THE HOUSTON NATURAL GAS BUILDING
CENTURY - GULF BUILDING COMPANY, OWNER

JOB NO. 918
DATE JAN. 31, '66
SHEET NO. S-6

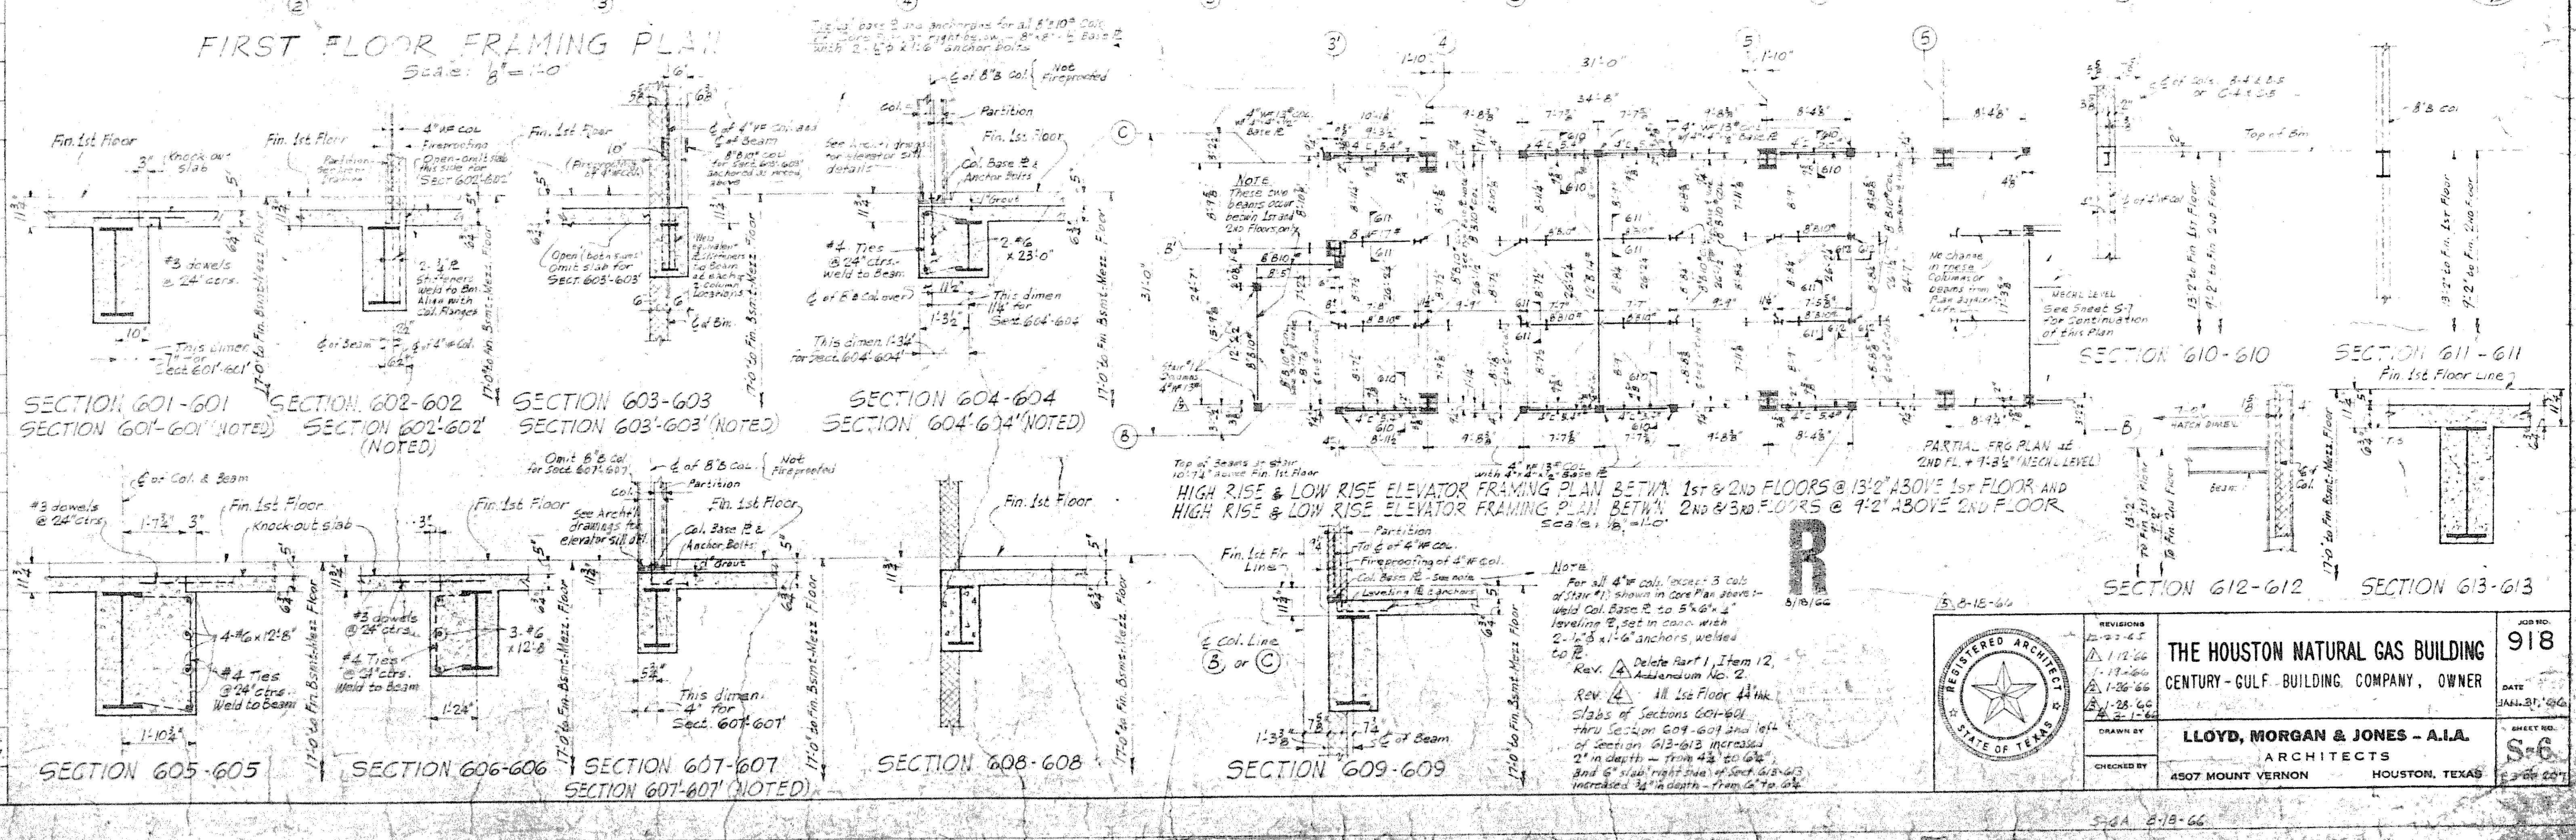
Rev. 4 Delete Part 1, Item 12, Addendum No. 2

Rev. 4 All 1st Floor 4 1/4" thk. Slabs of Sections 601-601 thru Section 609-609 and left of Section 613-613 increased 2" in depth — from 4 1/4" to 6 1/4". And 6" slab right side of Sect. 613-613 increased 3/4" in depth — from 6" to 6 3/4".
